## Sandleford Park, Newbury

### APP/36: Lee Witts' rebuttal to Jon Bowden's Proof of Evidence

21<sup>st</sup> April 2021

## Appendix B –Review of Ground Water Mapping against Original Drainage Strategy (10309-SK-06)

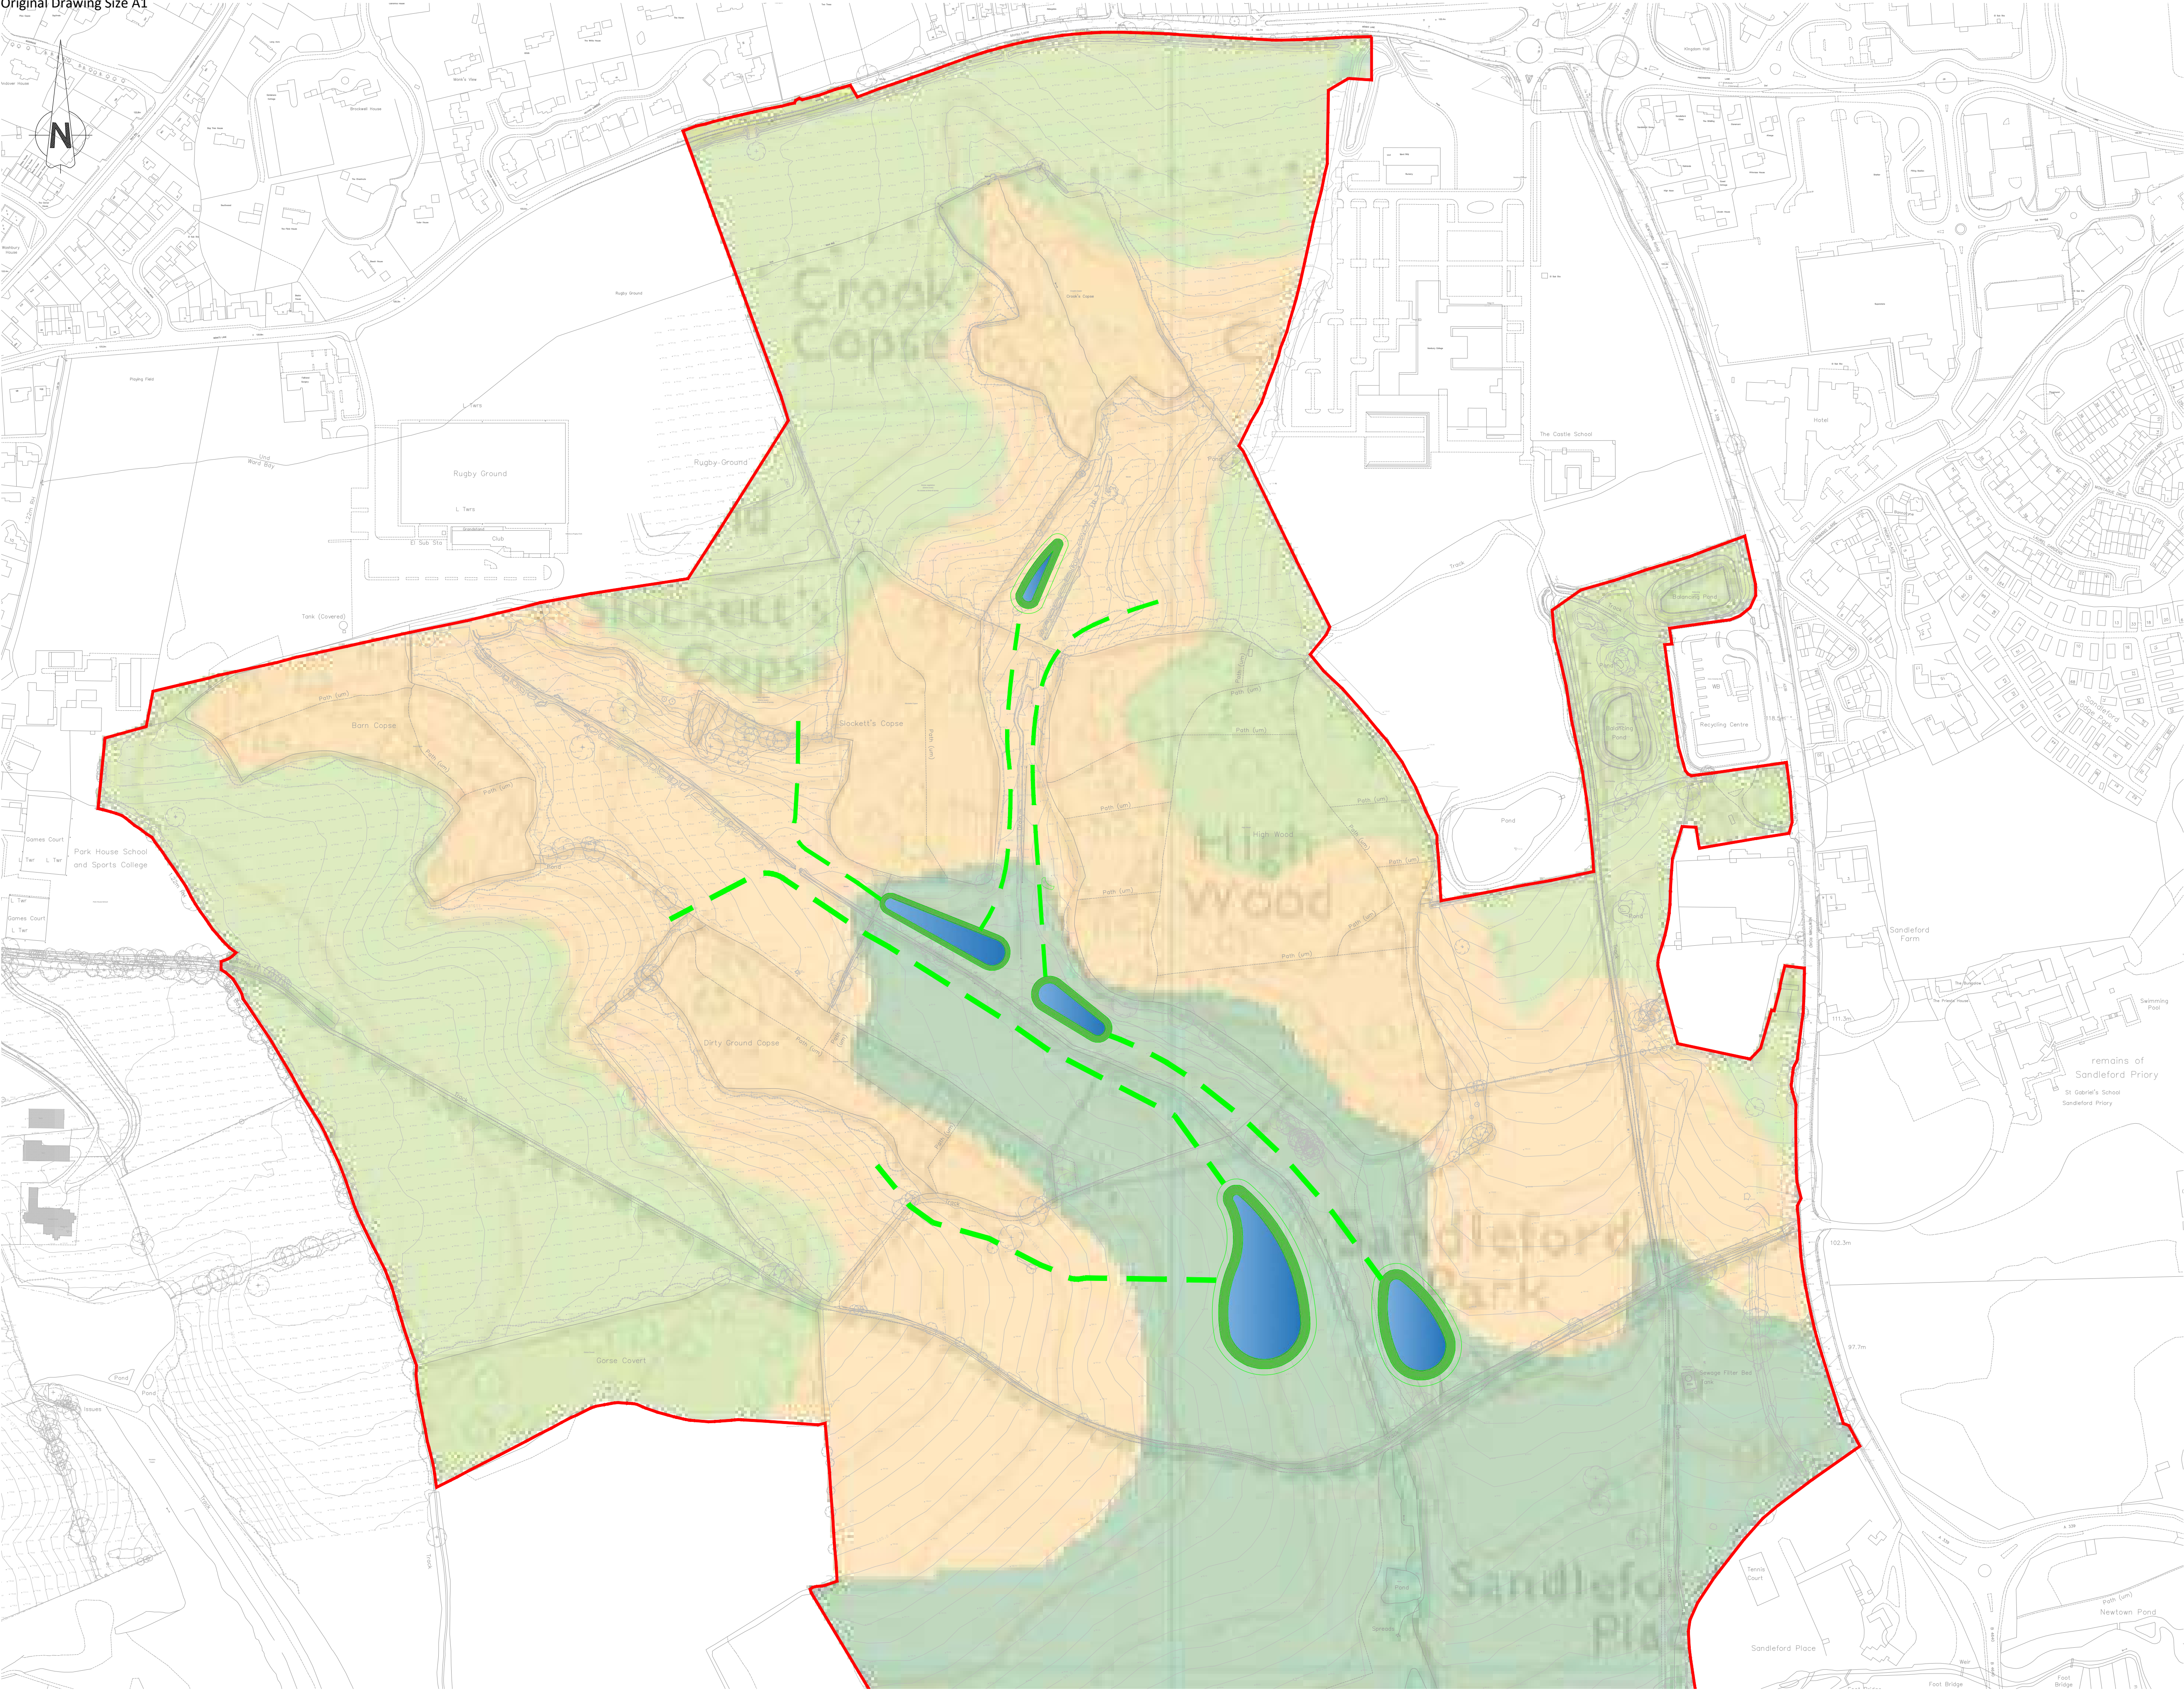
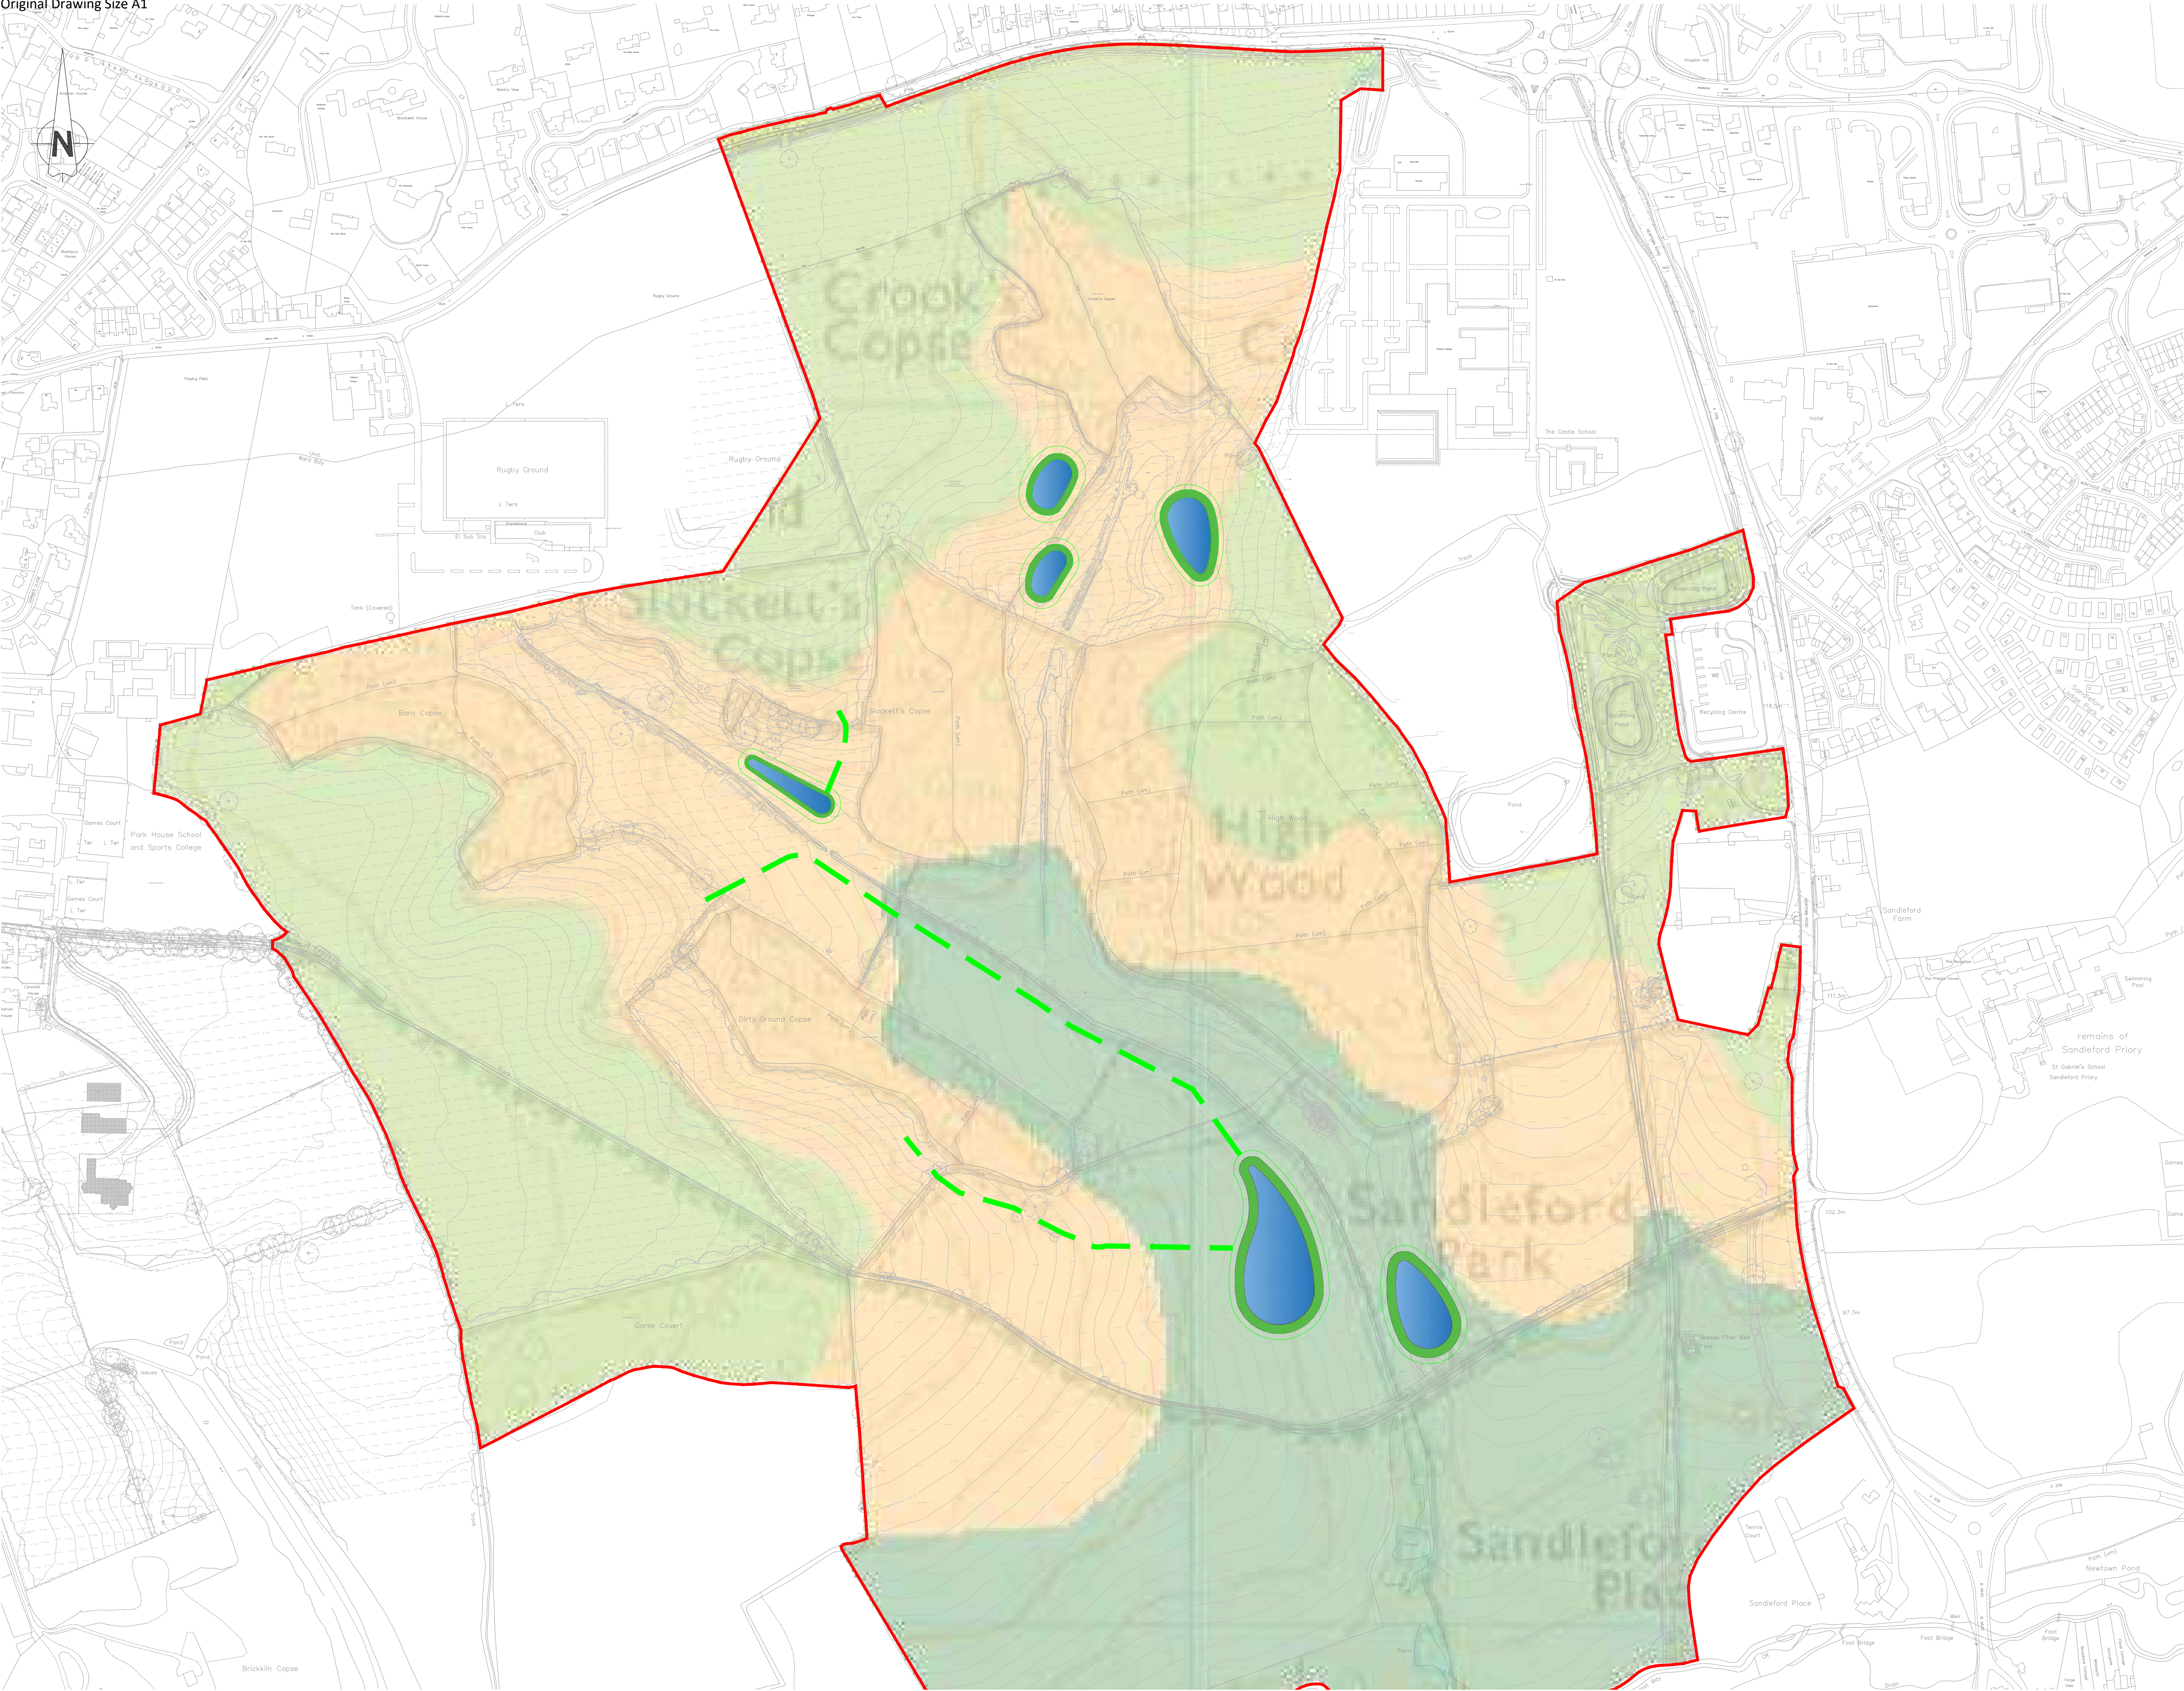
**Appendix A** – Review of Ground Water Mapping against Site Topography  
**Appendix B** – Review of Ground Water Mapping against Original Drainage Strategy  
**Appendix C** – Review of Ground Water Mapping against Alternative Drainage Strategy 1  
**Appendix D** – Review of Ground Water Mapping against Alternative Drainage Strategy 2
- 1.22 Firstly, groundwater does not slope parallel to the topography of the surface. Groundwater can only drop abruptly in the presence of a geological fault. However, there is no evidence that there is such a fault that occurs within the site boundary. Because of this there will not be such an immediate and dramatic change in groundwater levels due to a change in geology. The levels will rise or fall gradually across the site.

Drainage Strategy was issued and 10309-DR-03 A. Plan can be seen within APP/17 Appendix B. The plan is also appended to the FRA which is included within APP/17 Appendix D.
